## Agenda Item # 7 SUB-002883-2024

- Subdivision approval to create one (1) legal lot of record from one (1) metes-and-bounds parcel.

# CHANEY ADDITION SUBDIVISION

APPLICATION NUMBER 7 DATE April 18, 2024

# DETAIL SITE PLAN

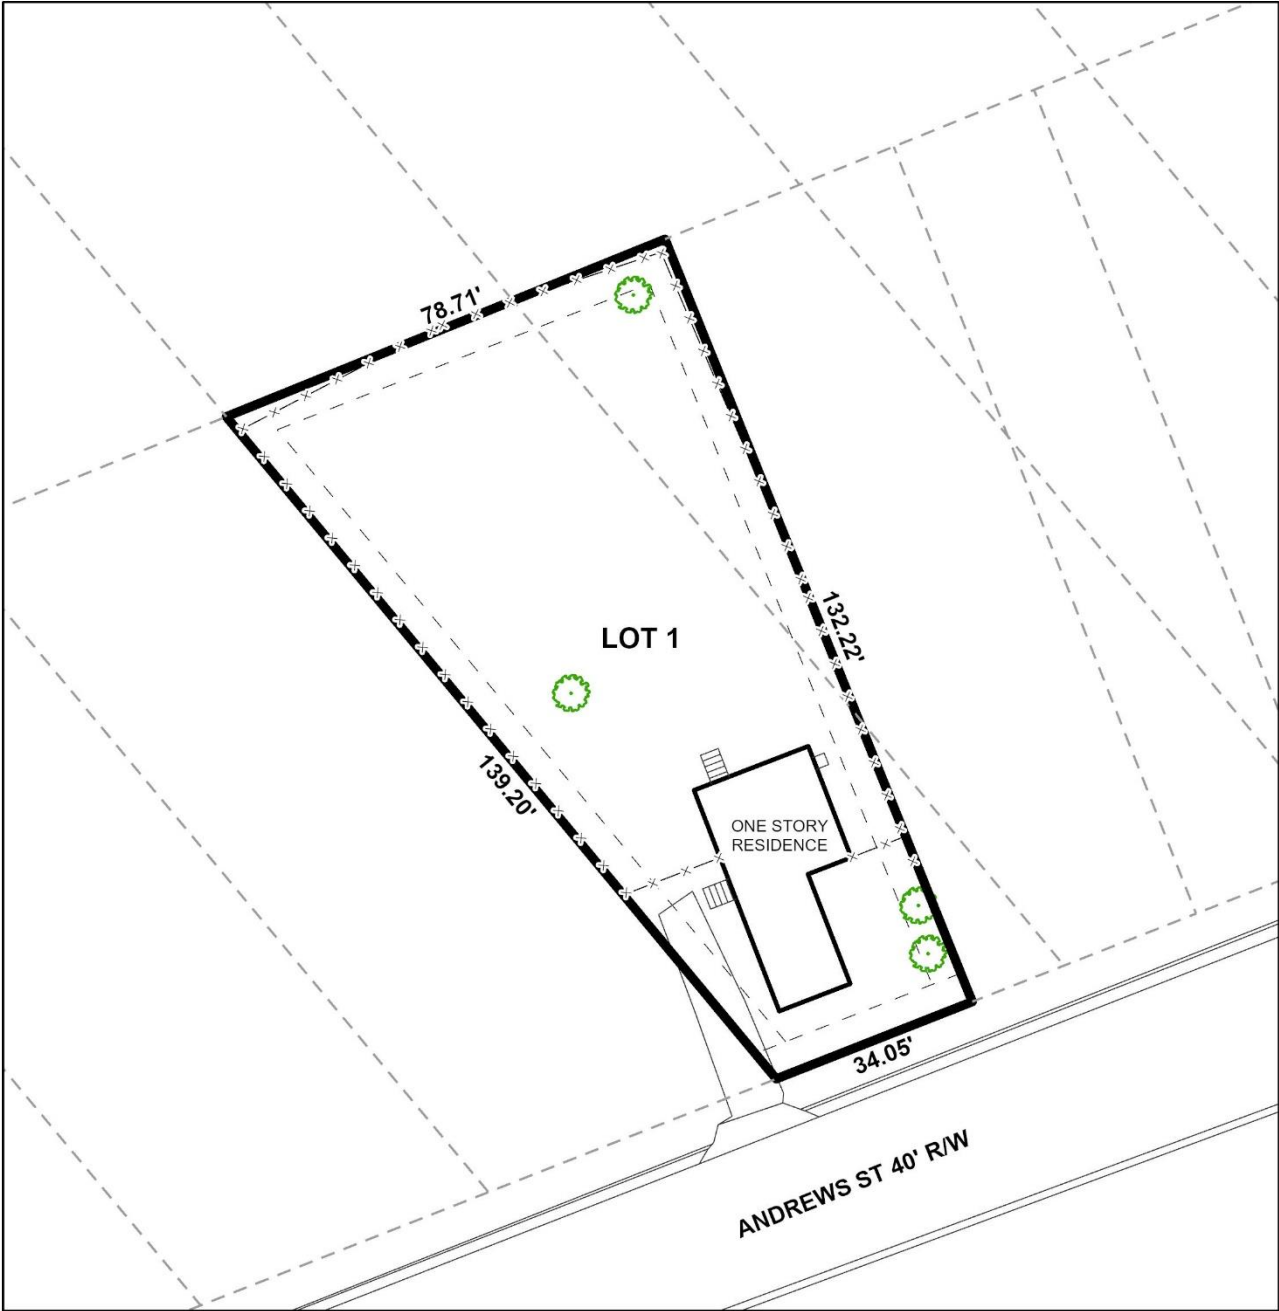
The site has frontage on Andrews Street, a minor street with curb and gutter requiring a 50-foot right-of-way. The preliminary plat illustrates a substandard 40-foot right-of-way at this location, which appears to be common along Andrews Street; however, the Planning Commission approved a subdivision at the corner of Andrews Street and Chavers Street in 1979 and required dedication to accommodate a 50-foot right-of-way. There do not appear to be any recent subdivisions along Andrews Street that would indicate additional dedication has since been required, but Section 6.B.9. of the Subdivision Regulations requires minor streets with curb and gutter to have a 50-foot right-of-way. Therefore, if approved, the plat should be revised to illustrate dedication sufficient to provide 25-feet from the centerline of Andrews Street. If the Planning Commission does not require additional dedication, a waiver of Section 6.B.9. will be required for approval.

The lot, as proposed, exceeds the minimum size requirements for lots served by public water and sanitary sewer in an R-1 Urban district, but it is not appropriately labeled in square feet and acres on the preliminary plat. If approved, revision of the plat to provide the size of the lot in both square feet and acres should be required, adjusted for any required dedication; or placement of a table on the Final Plat with the same information will suffice.

The width of the proposed lot (34± feet) at the front property line does not meet the minimum requirements of Section 6.C.2.(b)(3) of the Subdivision Regulations for residential lots within the Urban sub-district (50 feet). Furthermore, the lot exceeds the maximum width-to-depth ratio of Section 6.C.3. of the Subdivision Regulations. Such a lot design is not uncommon within the surrounding neighborhood, but the original plat from 1939 illustrates lots with compliant widths and width-to-depth ratios that have been altered by the conveyance of substandard parcels without prior Planning Commission approval. Nevertheless, previous development of the site may suggest that a substandard lot width will not negatively impact future development of the property.

A 5-foot front yard setback is illustrated along Andrews Street on the preliminary plat, in compliance with Section 64-2-5.E. of the Unified Development Code (UDC) for lots in the R-1 Urban district. This information should be retained on the Final Plat, if approved, adjusted for any required dedication; however, the Commission may also consider requiring an additional setback in lieu of right-of-way dedication, as previously stated.

Five (5)-foot setbacks are illustrated along each of the side and rear property lines, which is not required by the Subdivision Regulations. As such, removal of the side and rear setbacks from the Final Plat should be required, if approved.

1. Revision of the plat to illustrate dedication sufficient to provide 25 feet from the centerline of Andrews Street, or Planning Commission approval of a waiver of Section 6.B.9. of the Subdivision Regulations, or the provision of additional front yard setback to accommodate future right-of-way width;

2. Revision of the plat to provide the size of the lot in both square feet and acres, or provision of a table on the Final Plat with the same information, adjusted for any required dedication;

3. Retention of the 5-foot minimum front yard setback along Andrews Street on the Final Plat, adjusted for any require dedication, or the provision of additional front yard setback to accommodate future right-of-way width;

4. Removal of the side and rear yard setback lines from the Final Plat;
5. Compliance with all Engineering comments noted in this staff report;
6. Placement of a note on the Final Plat stating the Traffic Engineering comments noted in this staff report;
